## Clutch friction plate design change on Ford models

**Clutch kits affected:** 821321, 826042, 826044, 826048, 826053, and 826493

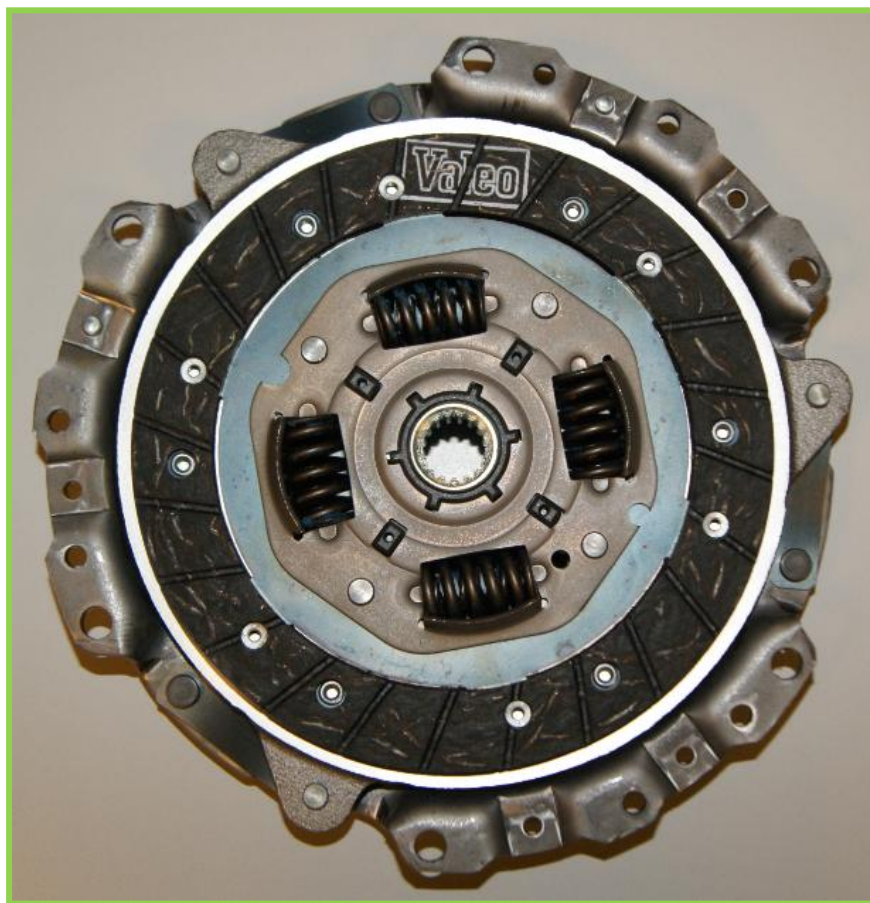
Please note for the clutch kits listed below there has been a modification made by Ford. The clutch friction plate has now been reduced from 220mm to 210mm making it 10mm smaller than the clutch cover. This will in no way effect the performance of the clutch.

*Please note the friction plate is 10mm smaller in diameter than the clutch cover*
